**Subject: Northern Regional Library Facility (NRLF) Phase 4 – Bio Retention Pond
Soil Management Plan, Sampling Approach
Richmond Field Station, University of California, Berkeley**

**NRLF Bio-Retention Pond
Proposed Sampling Location**

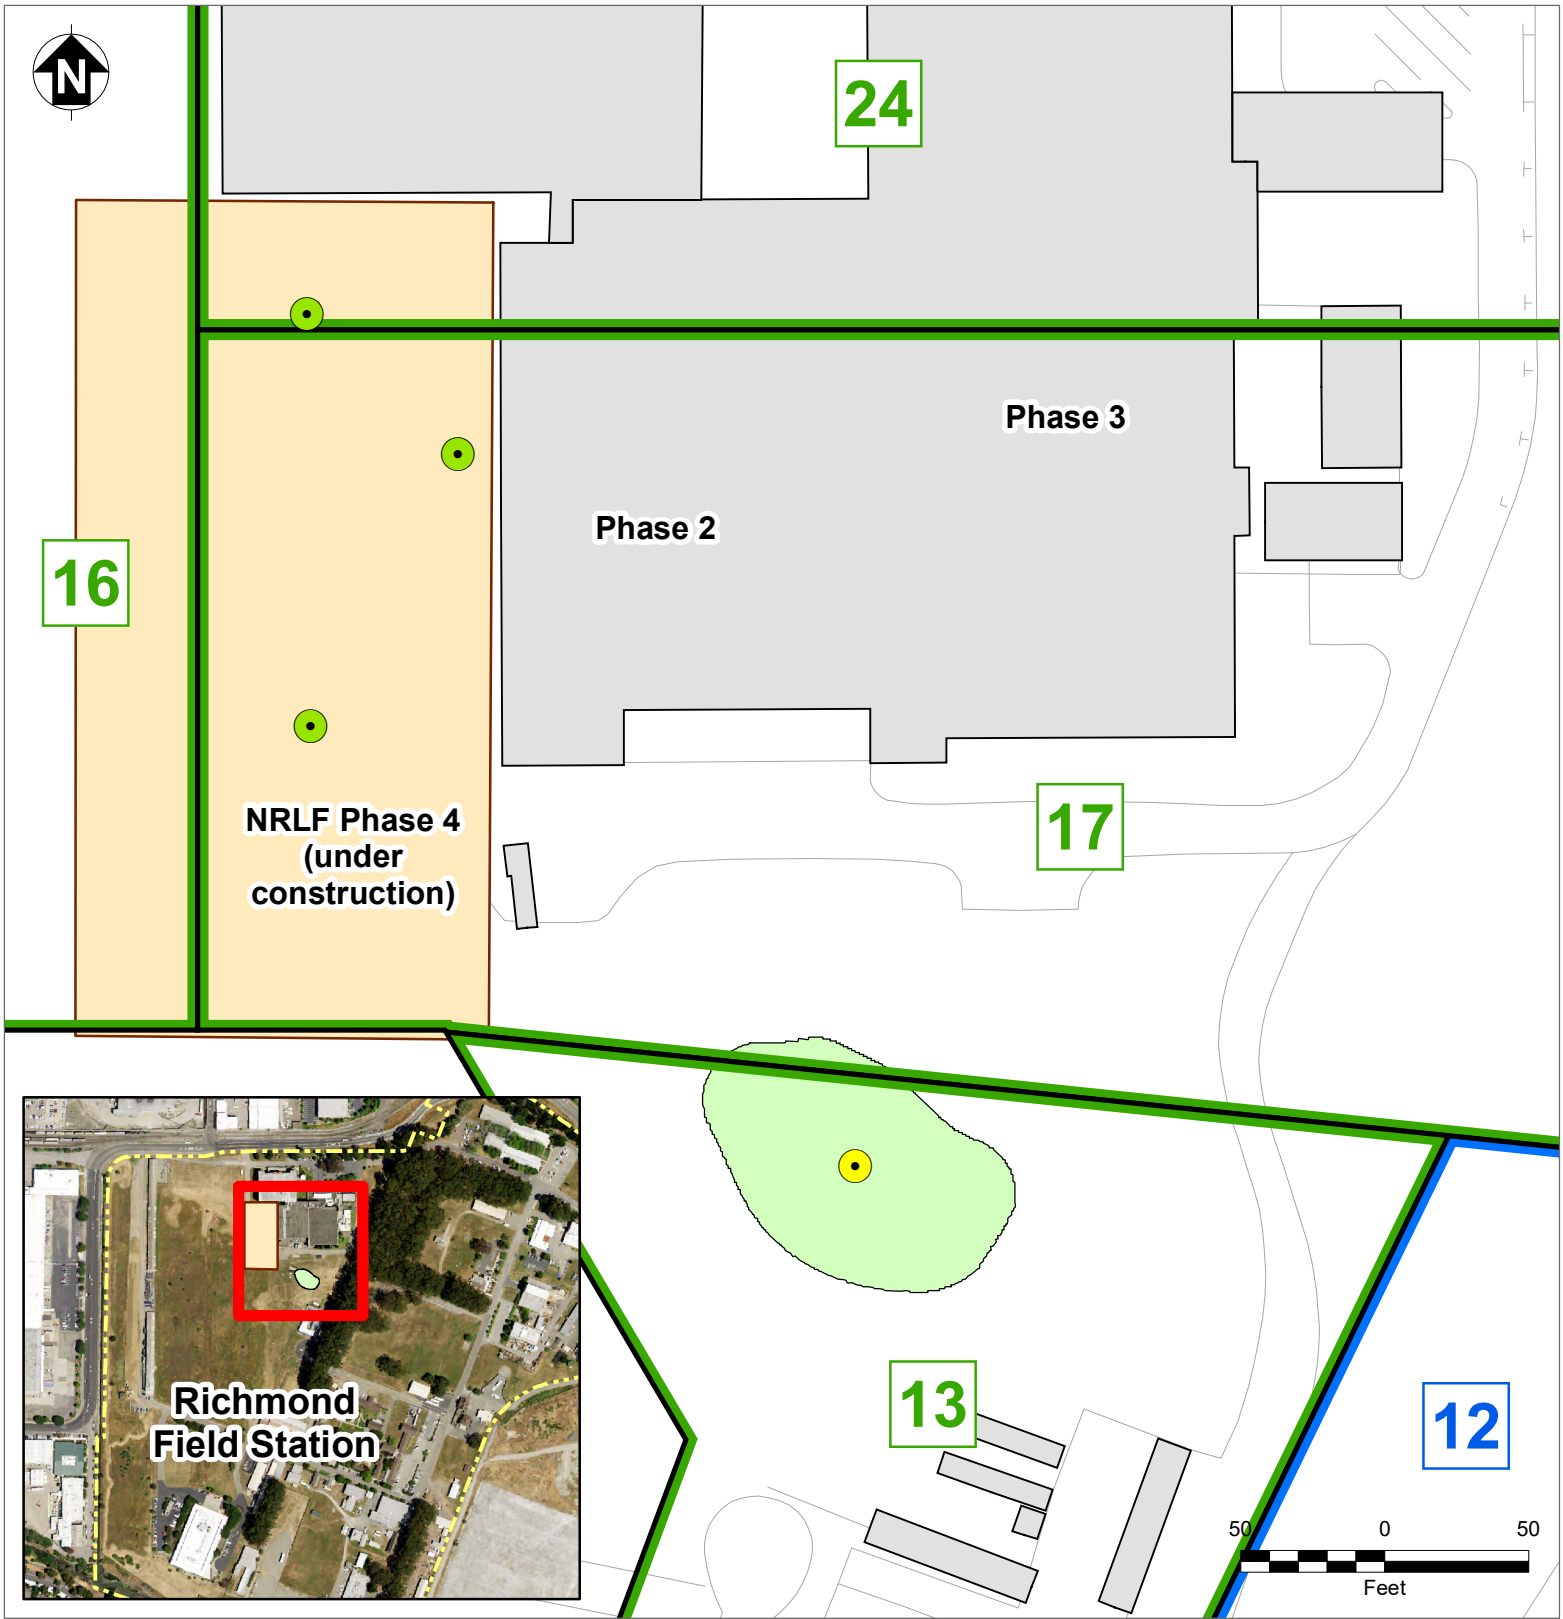
This letter addresses comments received from DTSC dated November 25, 2019, and replaces UC's previous letter dated November 21, 2019. The sampling approach has been modified to clarify that soil samples will have all foreign materials removed in the field. Soil sample jar volumes have remained unchanged per consultation with the analytical laboratory.

The project is located within SMP Areas 13, and 17, which are defined as low sampling density with arsenic, lead, mercury, polycyclic aromatic hydrocarbons (PAH), and polychlorinated biphenyls (PCB) as chemicals of concern. SMP areas, chemicals of concern, and sample frequency are presented in Section 4.1 and Table C-3 of the Soil Management Plan. Low sampling density areas dictate a minimum of one sample location per 15,625 square feet, mandating a minimum of one location for this project. UC Berkeley proposes to collect samples from one location within the excavation footprint; the location is presented on the figure following this letter.

Soil samples will be collected from depths of 0-0.5 and 2-2.5 feet below the depth of planned soil disturbance, for a total of two samples. This will allow documentation of potential residual soil contamination beneath the excavation.
